V1A_X PCB as of 9/1/23

This is a few notes about the new V1A_Rx DDS pcb.

First off, the x will denote the revision, we are currently on rev 4. (V1A R4)

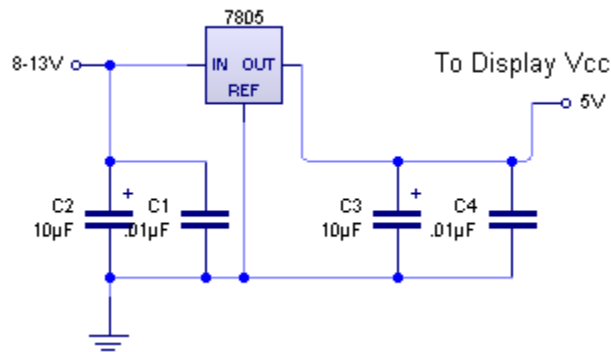
The silkscreen was blurry on V1A R5, please use the diagram below for reference of the wiring connections until V1A_5 is corrected.

VCC- 5V RedBlk / SDA-Data ORN / SCL-Clock BLU / D2-Encoder BRN

D3-Encoder WHT / BT-Encoder Button GRN / ASW-Auto Scan Switch BluBlk

CLV-Clairifyer 5v RedBlk / CLC-Clairifyer Center GRY / SPS-Spectrum Scan Wht/Blk

PTI-Push to talk in Orn/Blk / PTO-Push to talk out BrnBlk / RB-Grey

SCL-Scan Logic YelBlk
